INTRODUCTION

San Diego Gas & Electric Company (SDG&E) filed a Proponent’s Environmental Assessment (PEA) as part of its application for a Certificate of Public Convenience and Necessity (CPCN) for the Sycamore to Penasquitos 230kV Transmission Line Project (Proposed Project) to the California Public Utilities Commission (CPUC) in April, 2014. Subsequent to filing the PEA and publication of the Draft Environmental Impact Report (EIR) by the CPUC, minor project engineering and design refinements (Minor Design Refinements) were made to SDG&E’s Proposed Project. Additionally, SDG&E has performed a preliminary review of the alternatives analyzed in the DEIR and has included suggested refinements to those alternatives primarily for feasibility reasons. These changes were the result of ongoing engineering, updated construction planning/sequencing, and new design specifications.

Sycamore to Peñasquitos 230kV Transmission Line Project

Exhibit 1 - Updated Proposed Project Route Map

Alternative 5 CC MM CP Shift

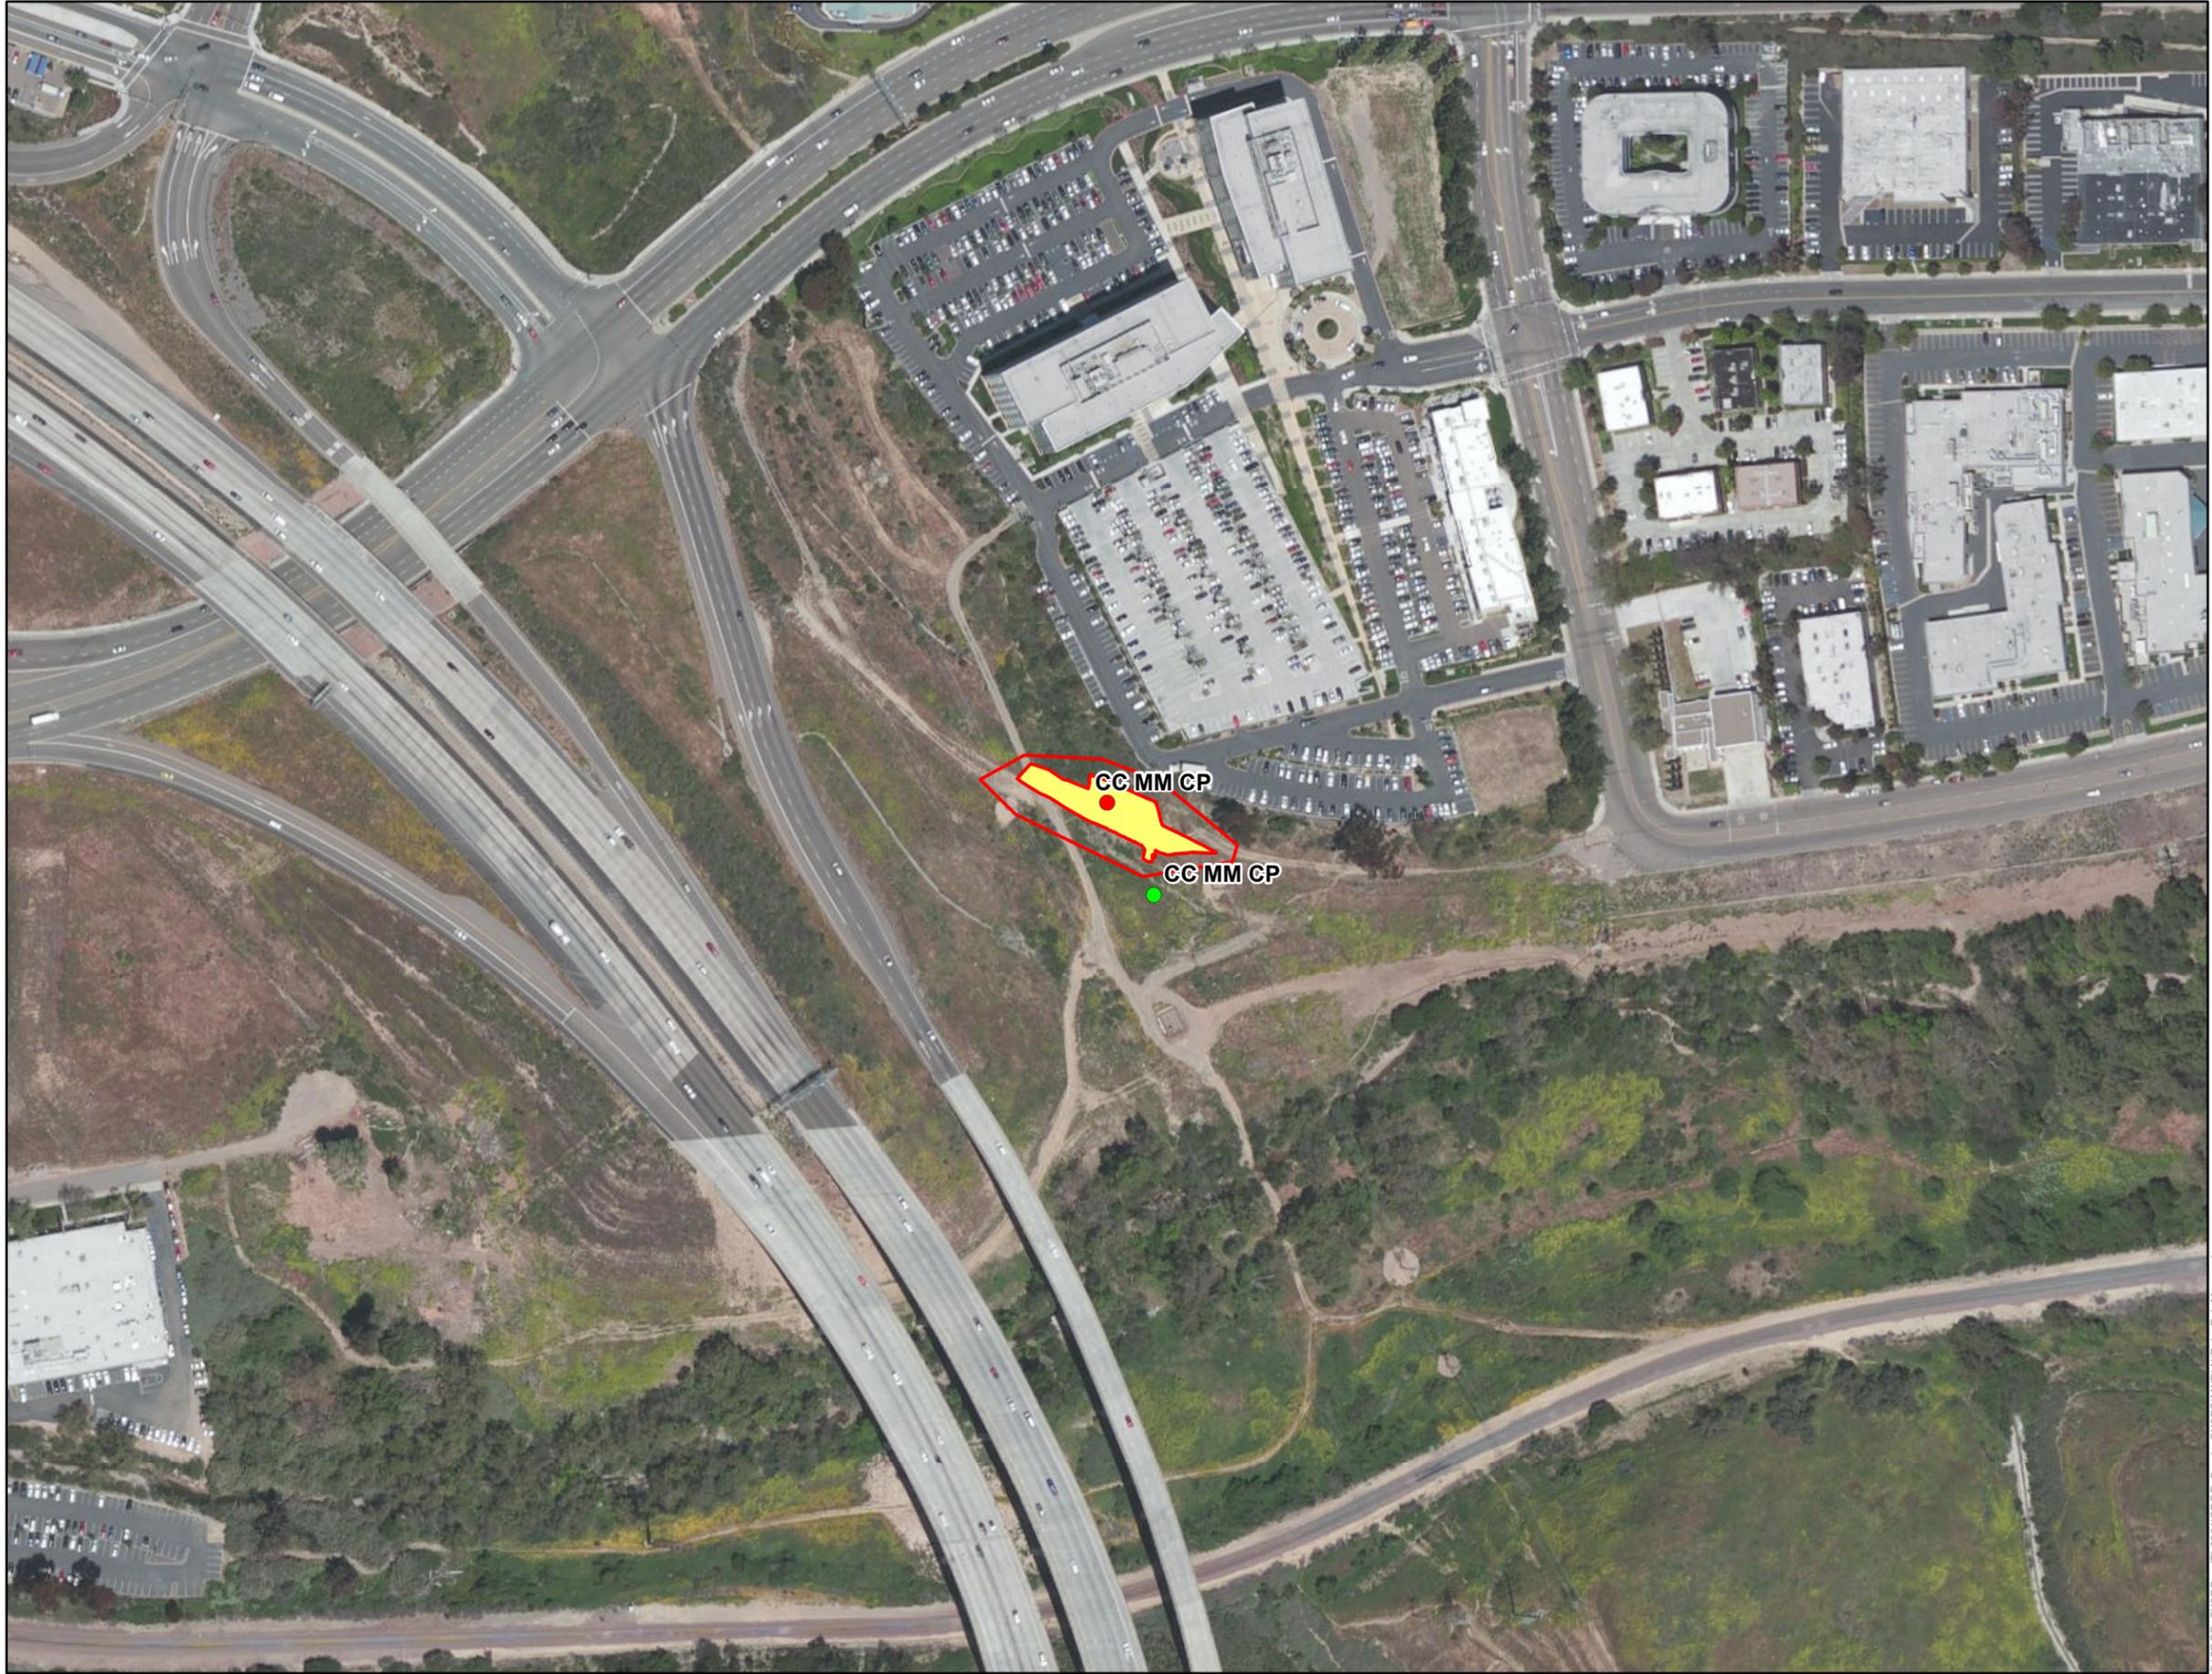
- Additional I-15 Crossing Options
 - Option 1 (preferred): Underground within existing Bridge over the I-15.
 - Option 2: Span I-15 solely via two cable poles.
- Cable Pole Refinement (Structure CC MM CP)
 - Cable Pole CC MM CP is proposed to be shifted north (125 feet).
- Potential installation of ADSS (communication cable) in an underbuild position instead of installing OPGW along the top of existing structures.
- All applicable civil design changes noted for the Proposed Project would apply to Alternative 5 as well. Specifically this would include changes at structures P1 through P4.

**Exhibit 11 - Alternative 5
Staging Yards**

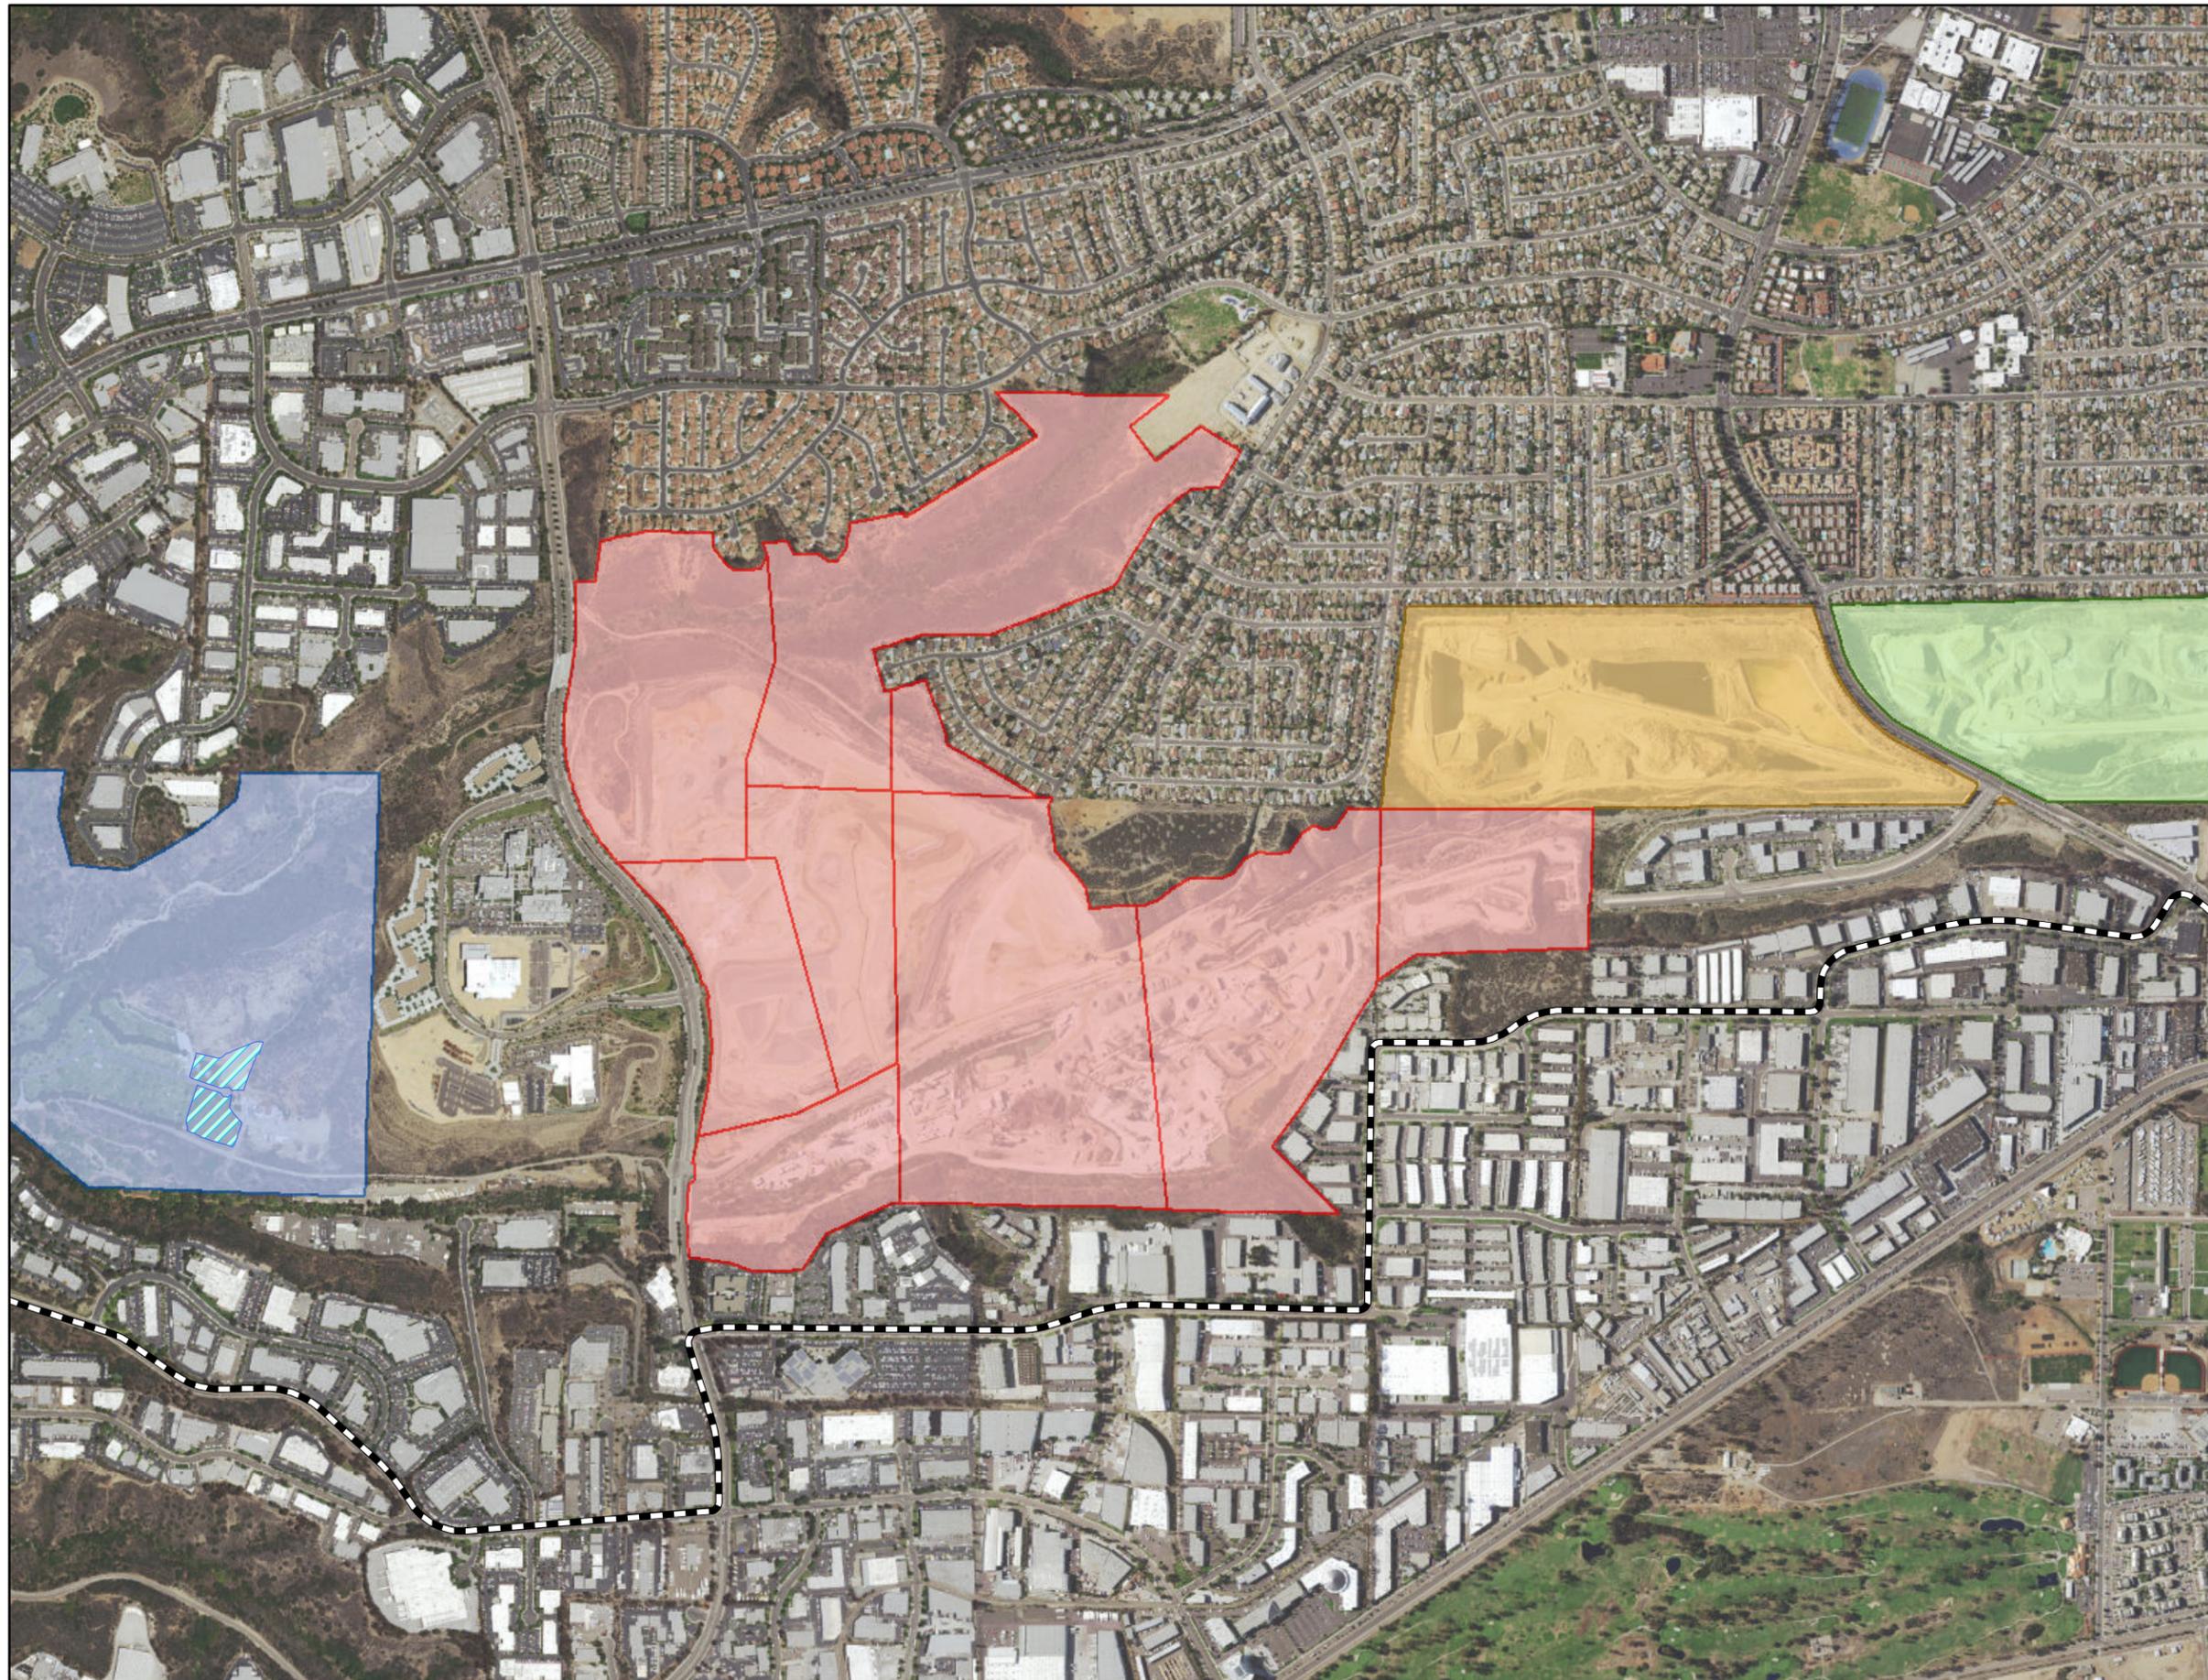
- As referenced in the Comment No. 12, Exhibit 10 contains a figure depicting SDG&E comments on DEIR Alternative 1 (cable pole south of Carmel Valley Road).
- As referenced in Comment No. 15, Exhibit 11 includes a figure of potential properties for staging yards along the Alternative 5 alignment.
- As referenced in Comment Nos. 236, 237, and 238, Exhibit 12 contains the Completed Geotechnical Study prepared for the Proposed Project.
